DRAINAGE AND TRANSPORTATION INFORMATION SHEET (REV 09/2015)

Project Title: TOWNHOUSES FOR BUCHANAN Building Permit #: _____ City Drainage #: F14D074

FIRE DEPARTMENT HYDRANT AND ACCESS PERMIT CHECKLIST

Re: Townhouses for Buchanan
4622 12th Street N.W.
Traffic Circulation Layout
Engineer's/Architect's Stamp 09-13-16 (F14-D074)

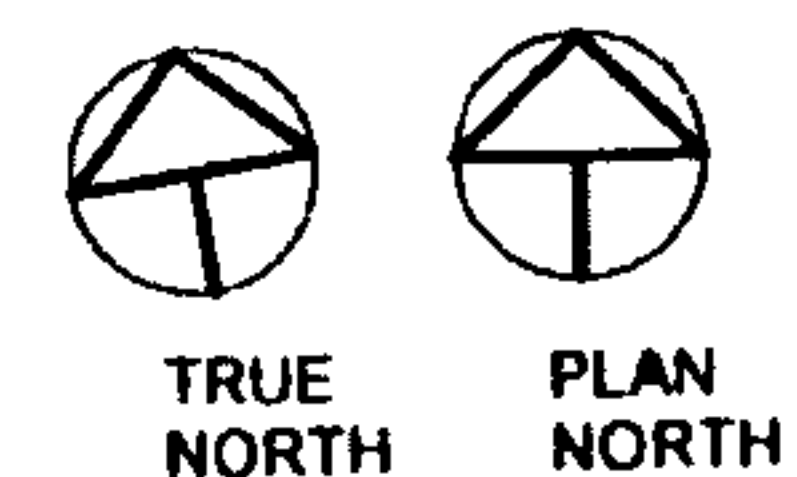
Any Residential Carts (not)
Access on ~~Commercial~~ Site Capable.
(Residential site) Any Solid Waste
Dept.
